FEC multilane bit serial interface for 40GBASE-R and 100GBASE-R

Ilango Ganga, Intel

Jan 13, 2009

- Proposed modifications to Clause 74 FEC for multilane bit serial operation with 40GBASE-R and 100GBASE-R PHYs
 - This presentation addresses comment #351 on P802.3ba-D1.1

Figure 74-3—FEC Transmit bit ordering

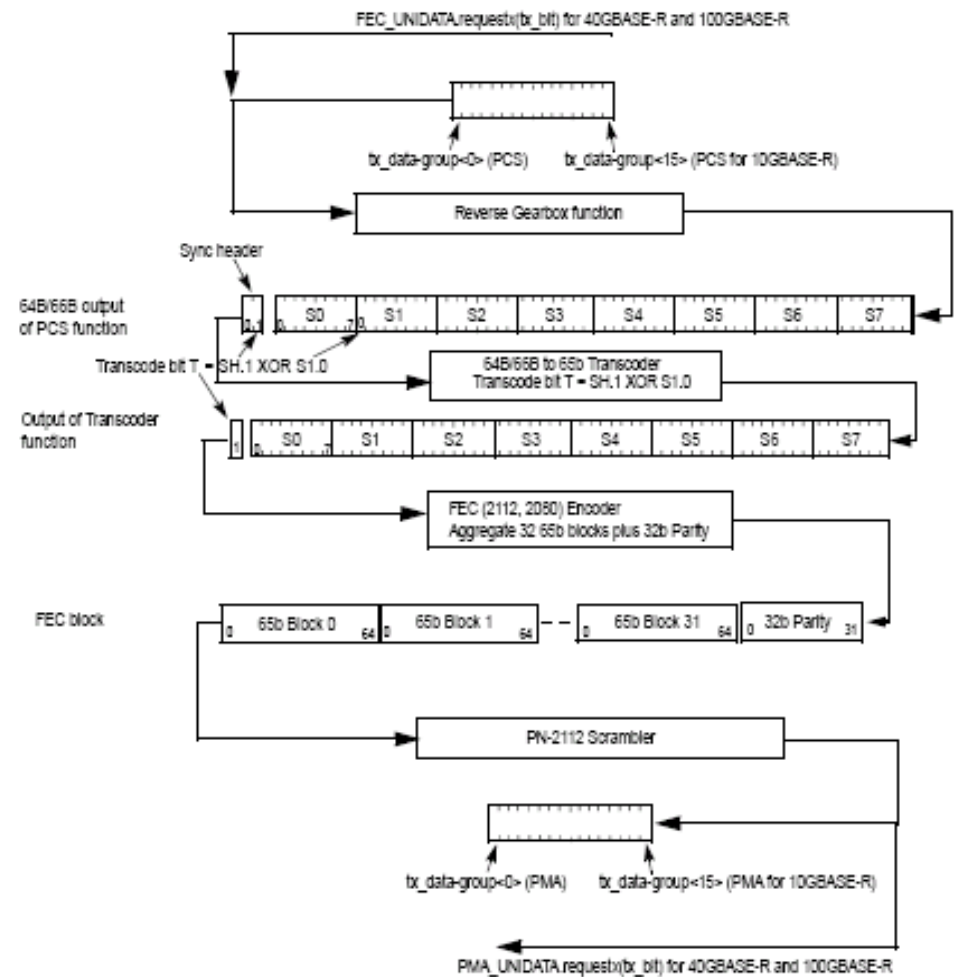
74.7.4.3 FEC tx bit ordering, Fig 74-3

- Replace Fig 74-3 as shown:

Figure 74-4—FEC (2112,2080) encoding

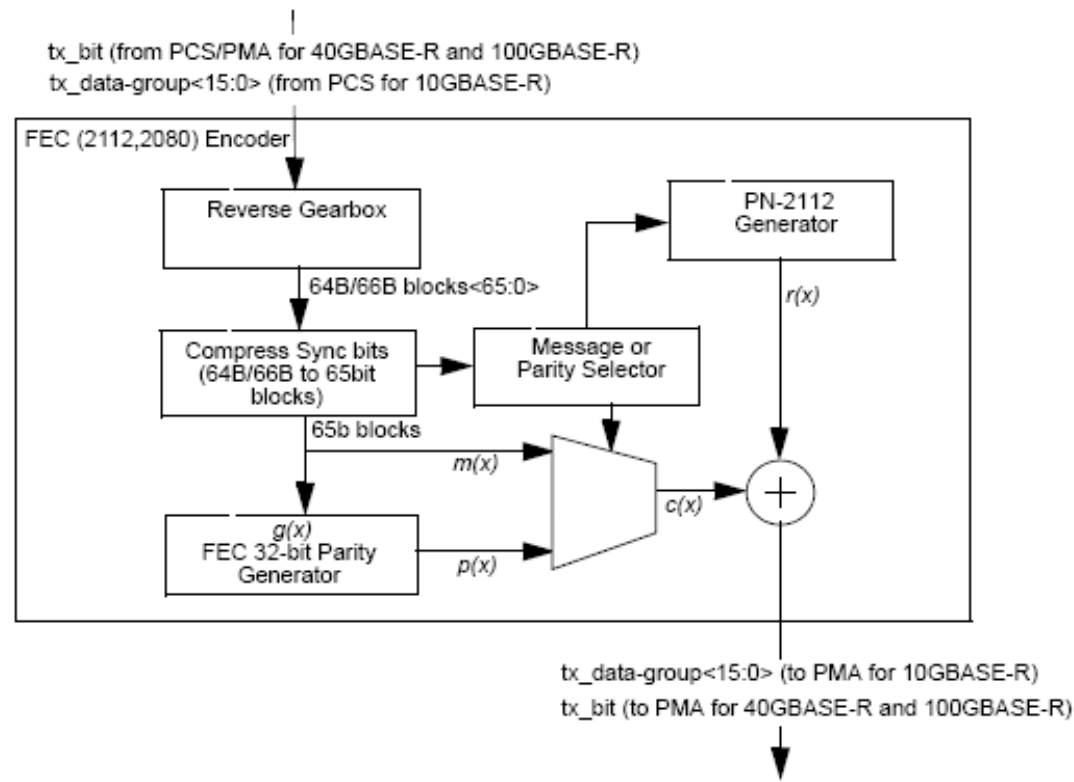
74.7.4.4 FEC encoder, Fig 74-4

- *Replace Fig 74-4 as shown below:*

Figure 74-6—FEC (2112,2080) decoding

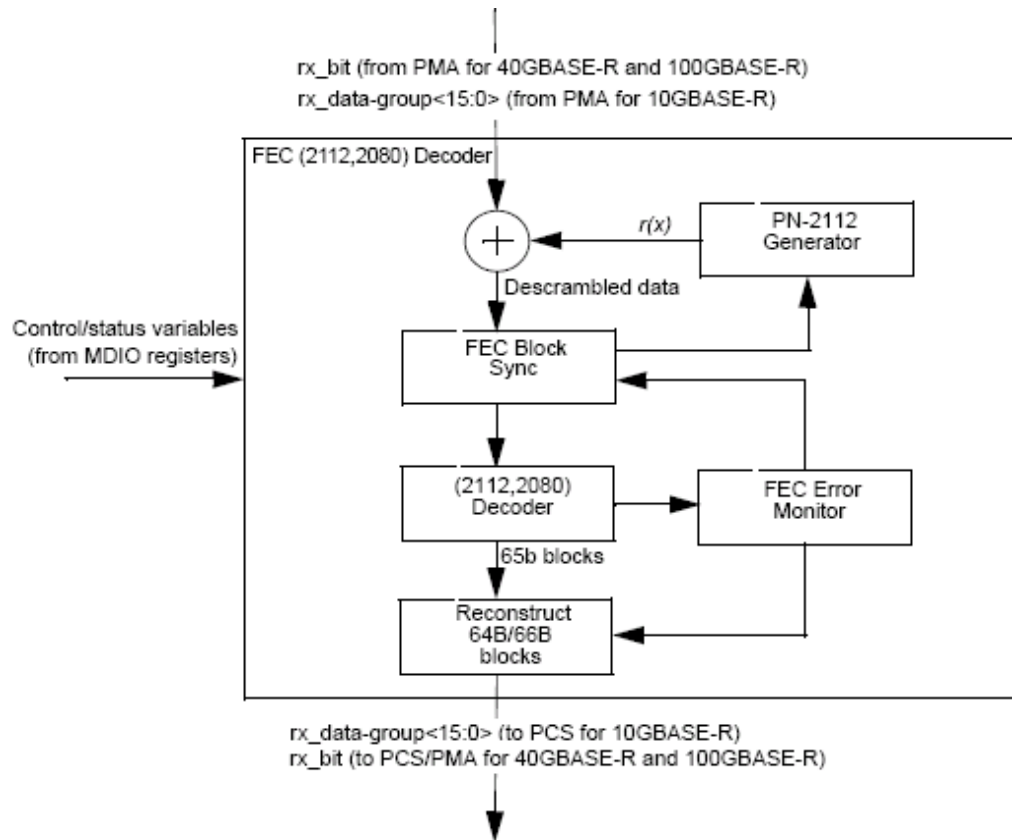
74.7.4.5.1 FEC decoding, Fig 74-6

- *Replace Fig 74-6 as shown below:*

Figure 74-7—FEC Receive bit ordering

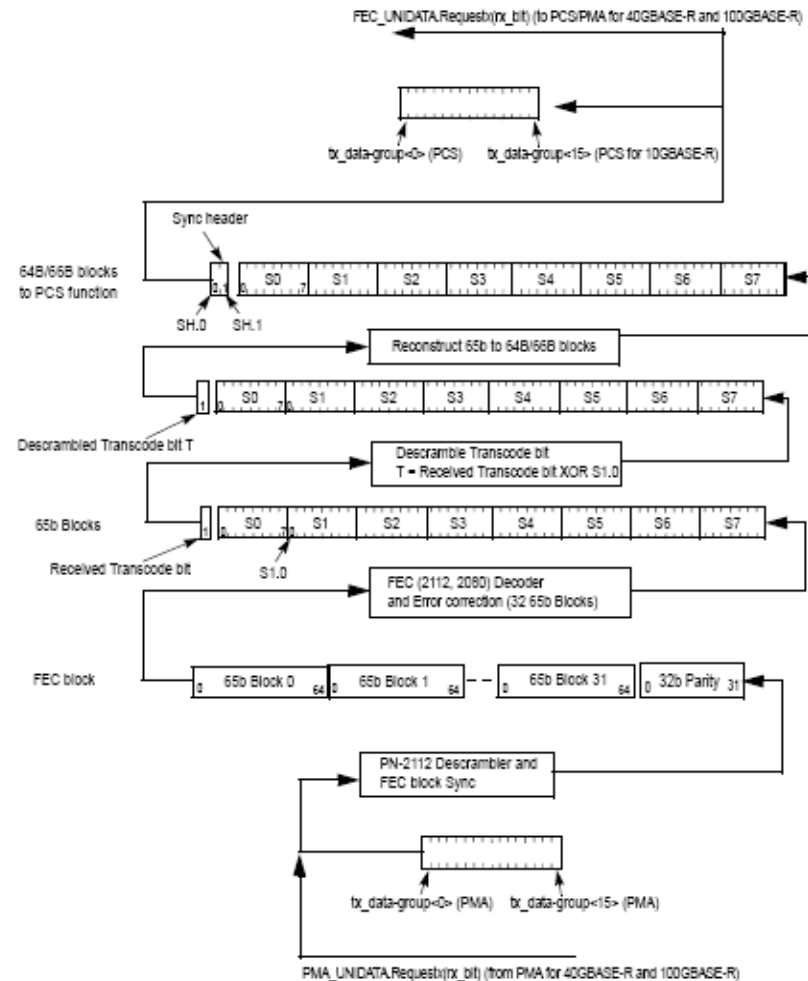
74.7.4.6 FEC rx bit ordering, Fig 74-7

- Replace Fig 74-7 as shown:
